SHAWNEE PASS ASSESSMENT DISTRICT 2025, NAKOMA SIDEWALK, AND NAKOMA CULVERT

CITY PROJECT NO. 11822
CONTRACT NO. 8783

- ADDENDUM #1 - 4/8/25
REVISED THE FOLLOWING:
D-3, D-5, P-5, U-5, U-7
- REVISION #1 - 7/8/25
REVISED THE FOLLOWING:
P1-P5
- REVISION #2 - 7/29/25
REVISED THE FOLLOWING:
D3, D4, U5, U6, U9

MARK	REVISION	DATE	BY
11822	1	7/7/2025 5:11 PM	Scale: 1" = 40'
Designed By: MFG			P-4

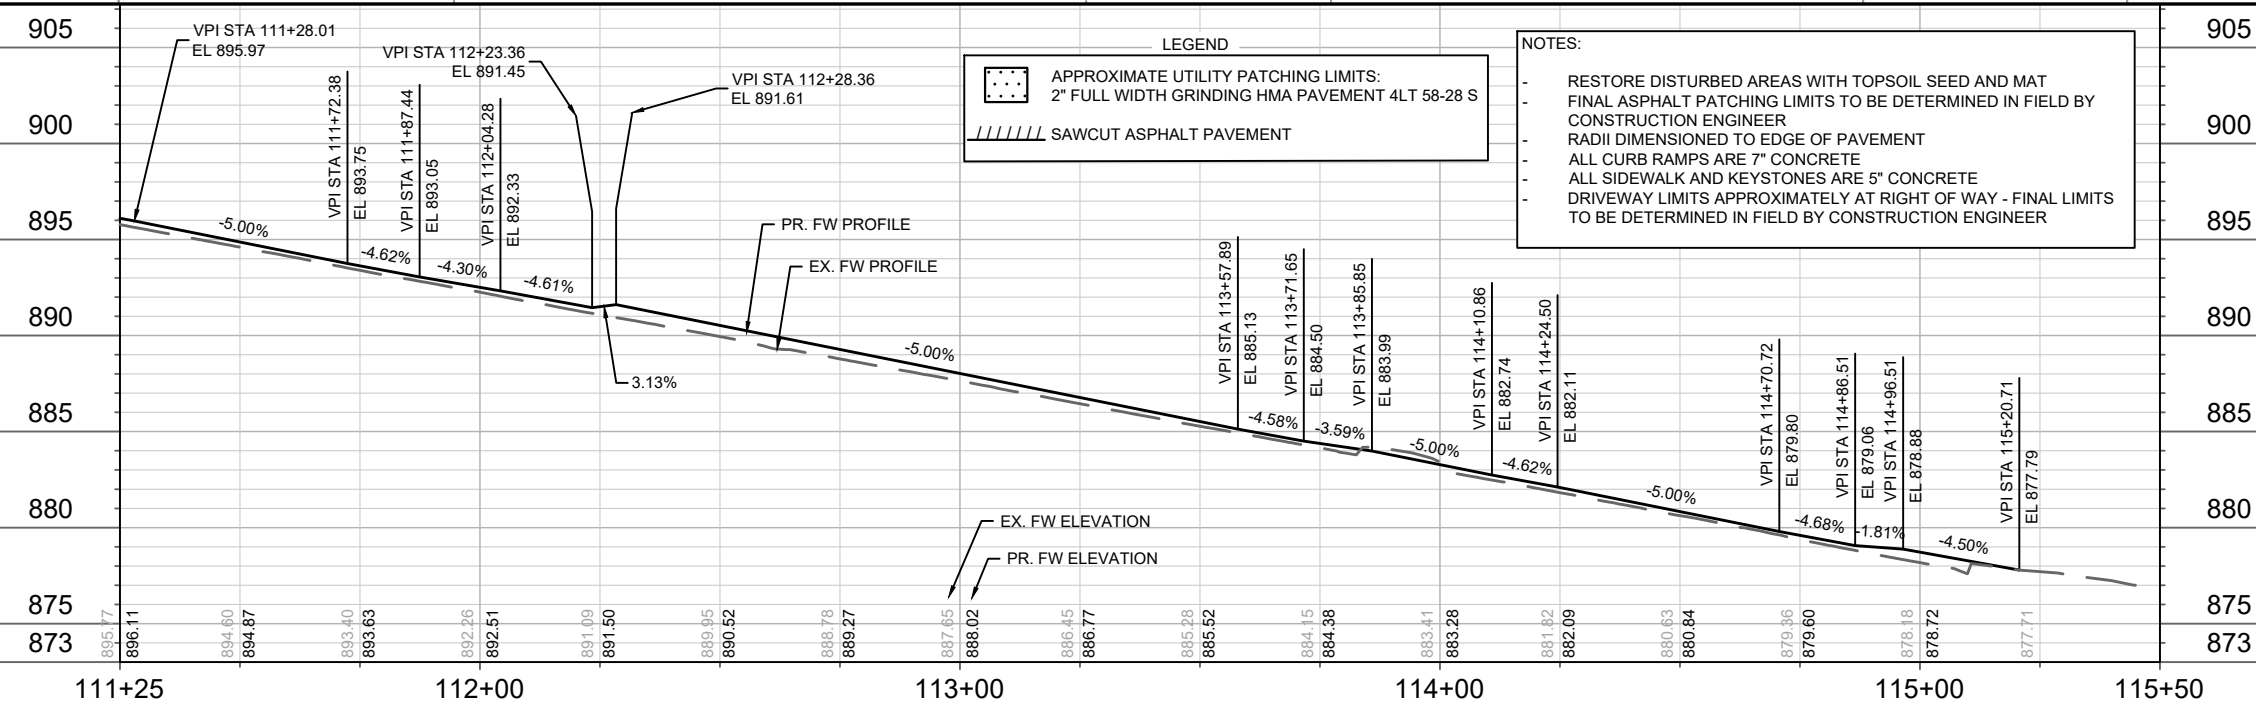
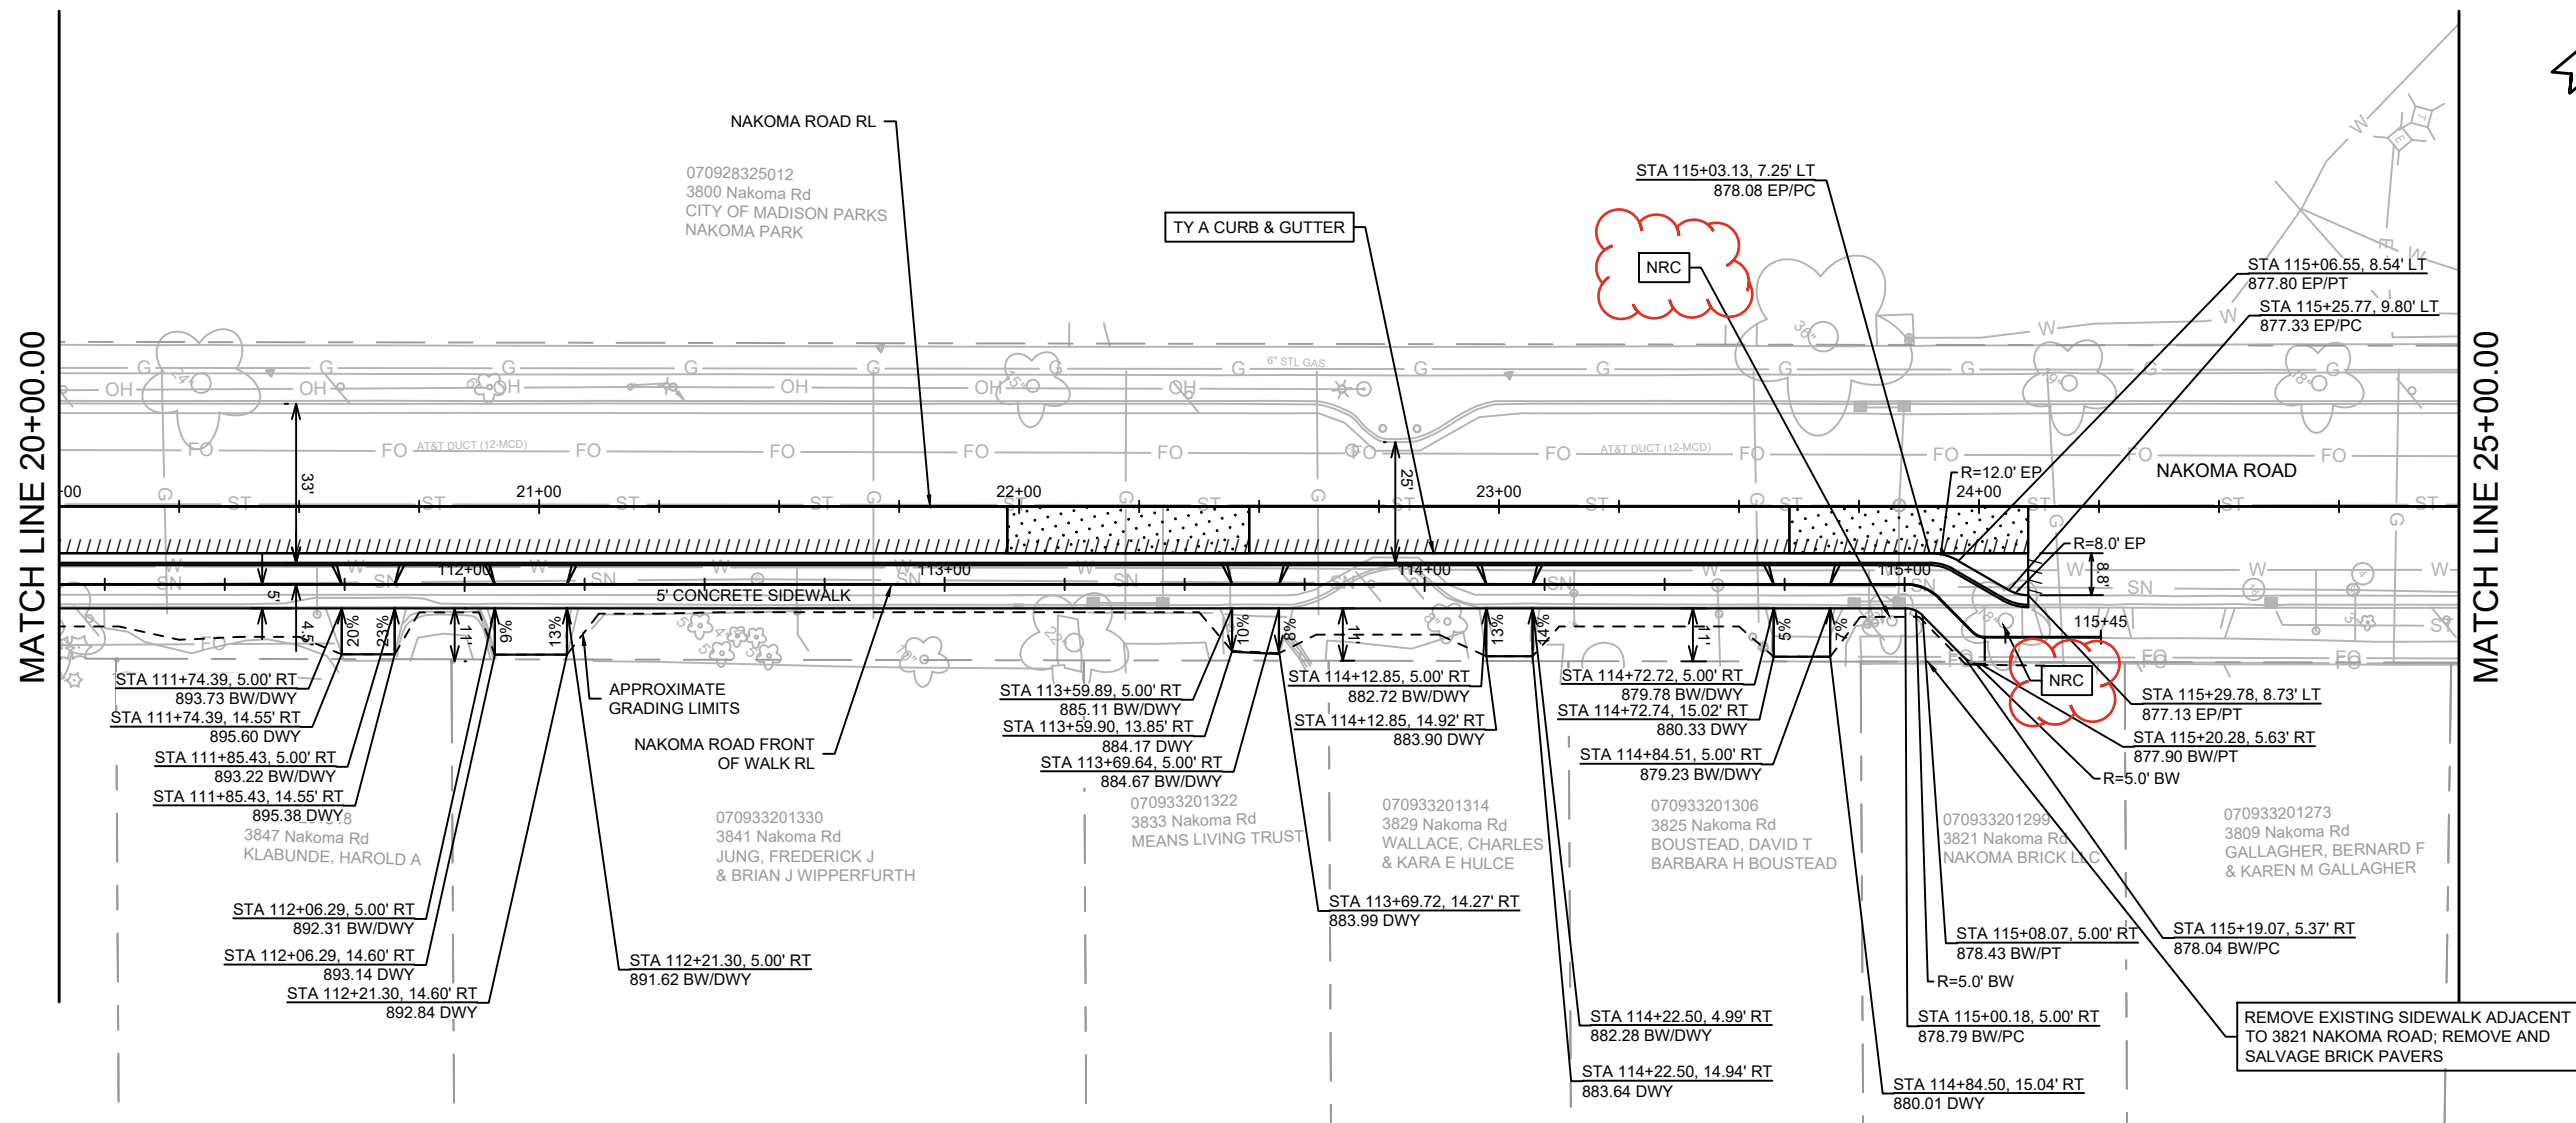
REVISION 1: MFG 7/8/25
ADDED NRC NOTES

11822
P-5

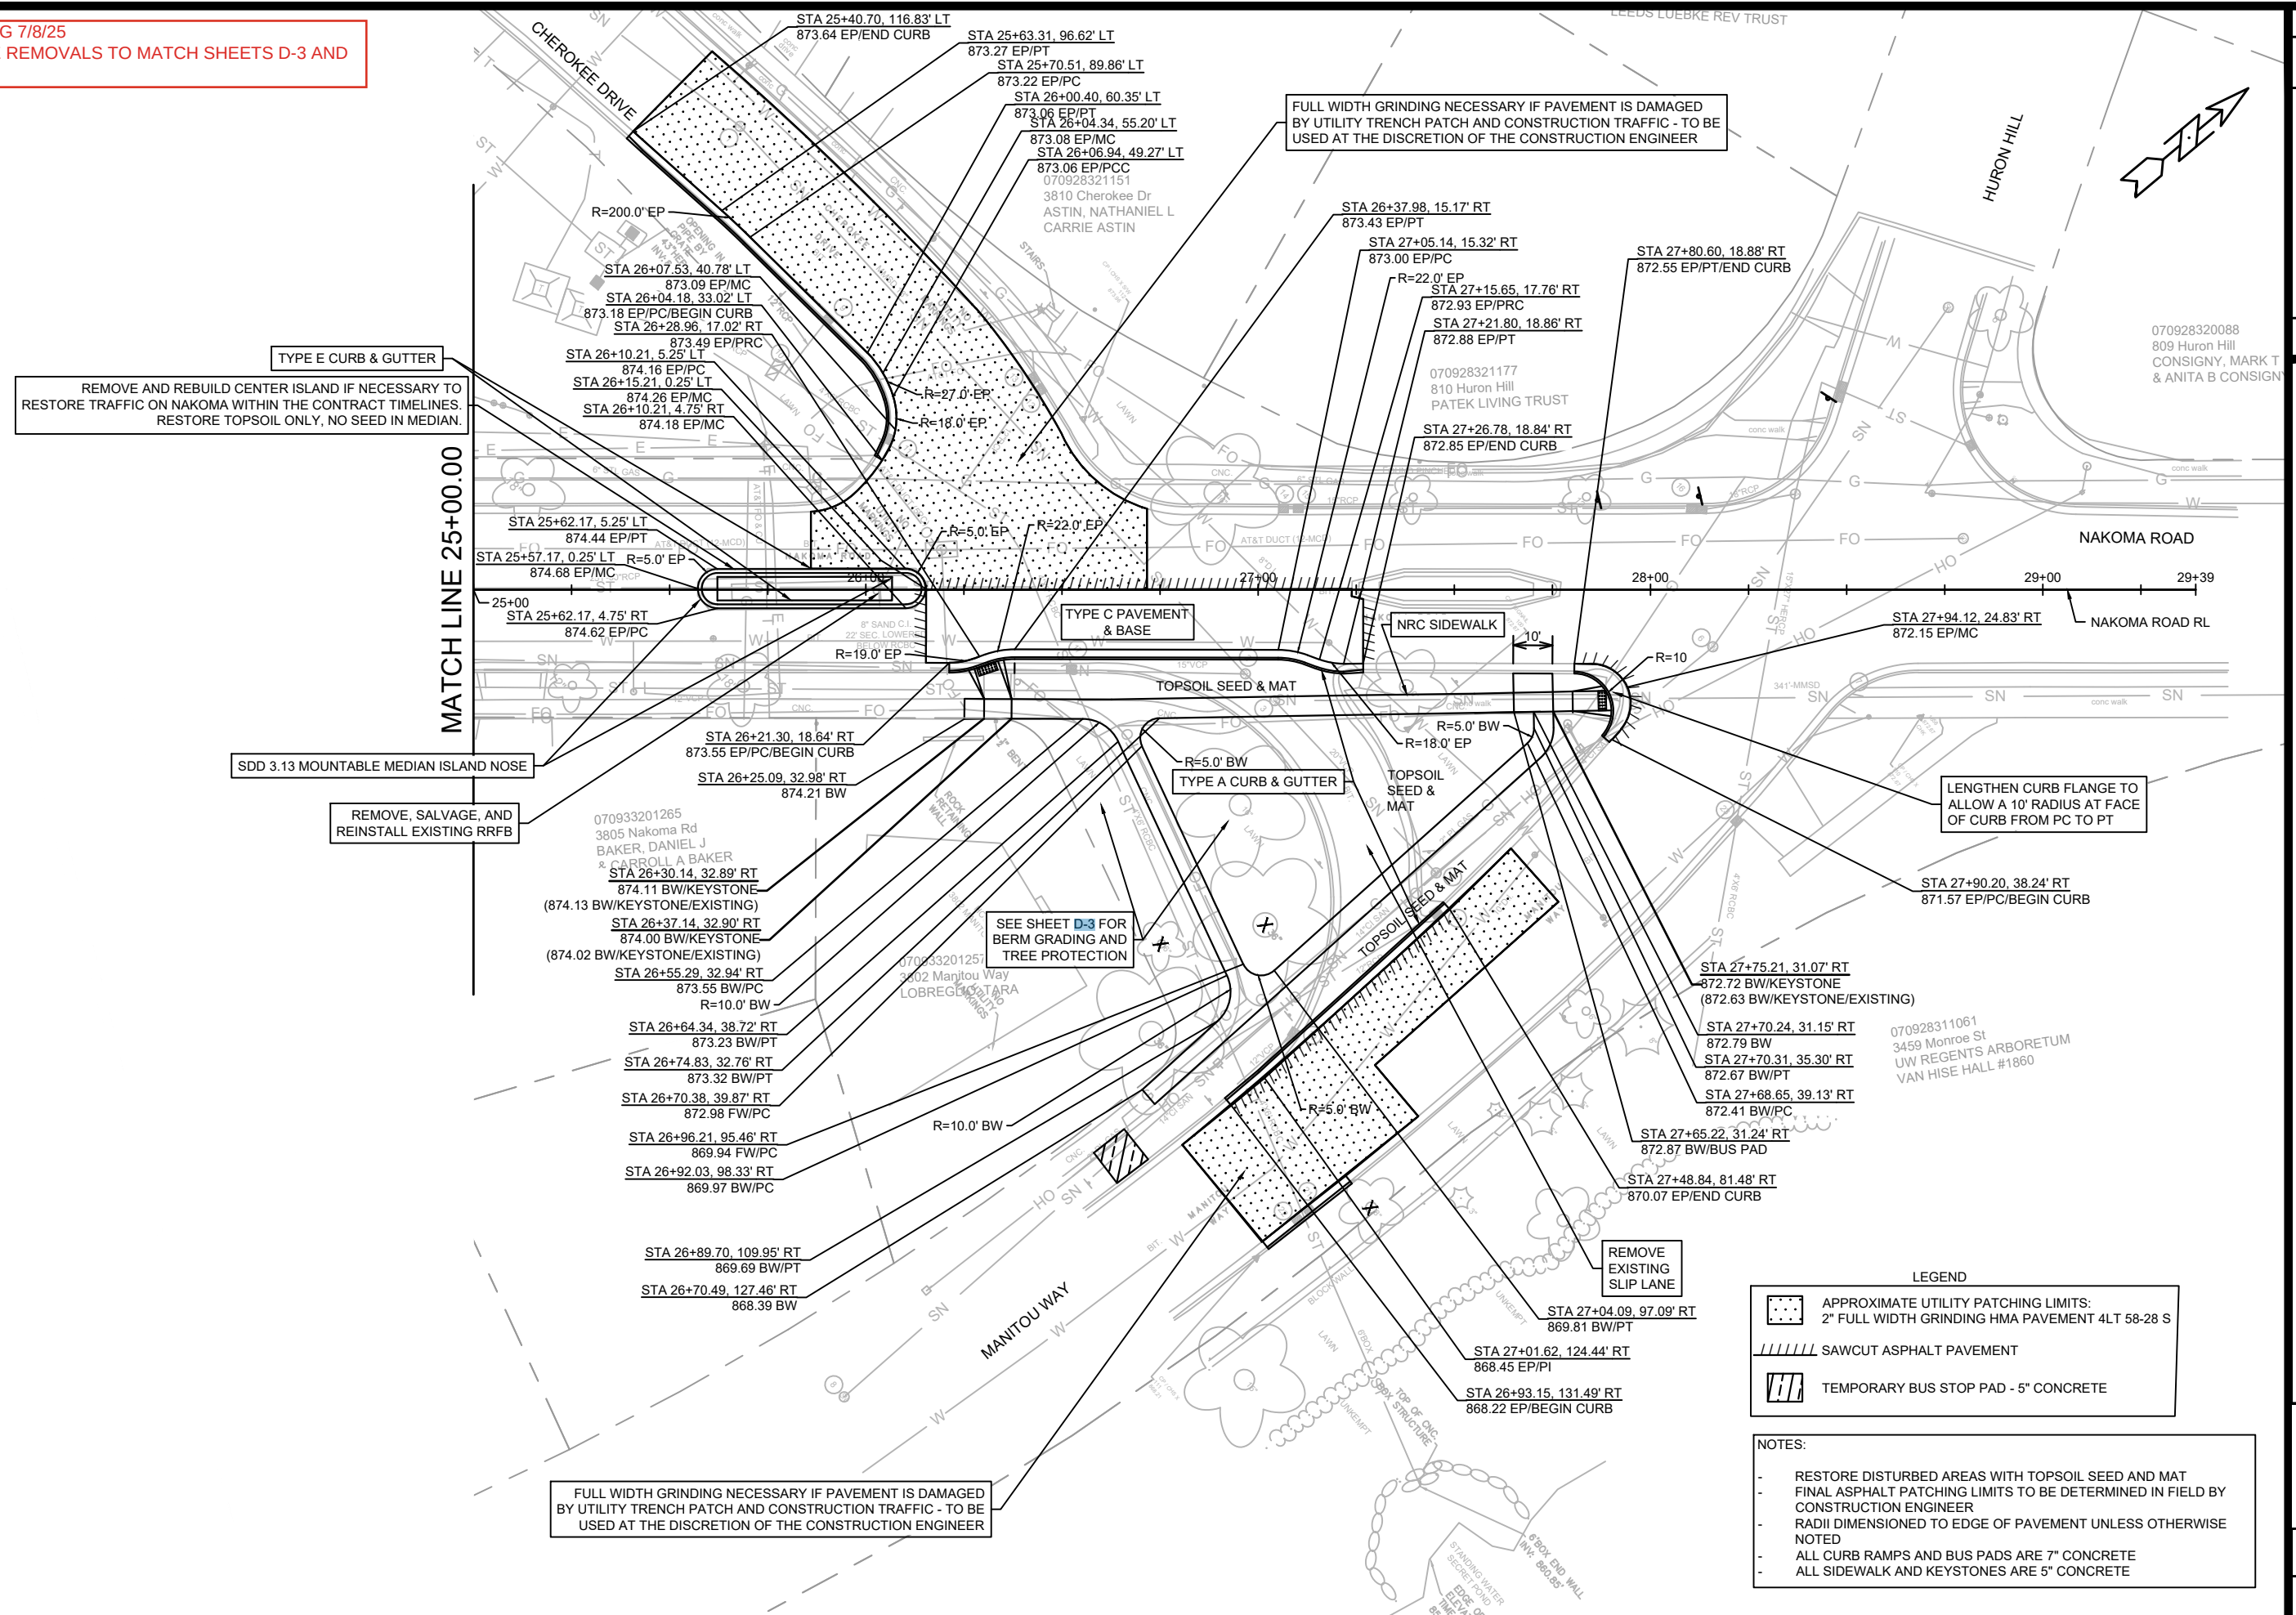
REVISION 1: MFG 7/8/25
UPDATED TREE REMOVALS TO MATCH SHEETS D-3 AND
U-5
